**World Forum for Harmonization of Vehicle Regulations****Working Party on General Safety Provisions****127th session**

**UN Regulation No. 118 (Fire resistance of interior materials)****Proposal for the Supplement 2 to the 04 Series of  
Amendments to UN Regulation No. 118 (Fire resistance of  
interior materials)****Submitted by the expert from the European Association of Automotive  
Suppliers \***

**"Example 3**

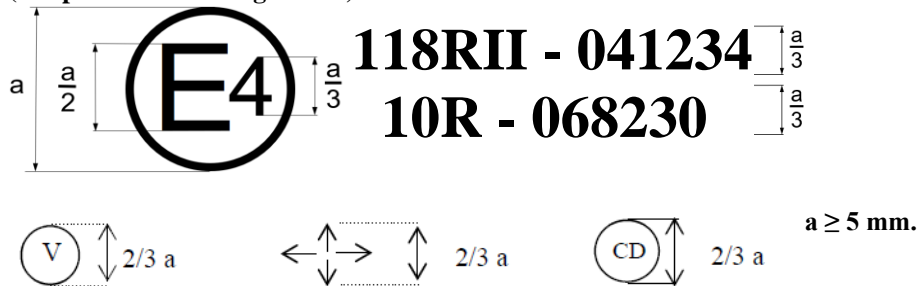
Insert new Example 3, to read:

4. The proposal also clarifies the (missing) dimensions of the symbol as in the case of the current Example 2 by adding **2/3a** to its right.

The above approval mark affixed to a component shows that the type concerned was approved in the Netherlands (E4) pursuant to Part II of Regulation No. 118 under approval number 041234 and Regulation No. 10<sup>1</sup> under approval number 068230.

The first two digits of the approval number indicate that, at the date when the respective approvals were given, Regulation No. 118 included the 04 series of amendments and Regulation No. 10 included the 06 series of amendments.
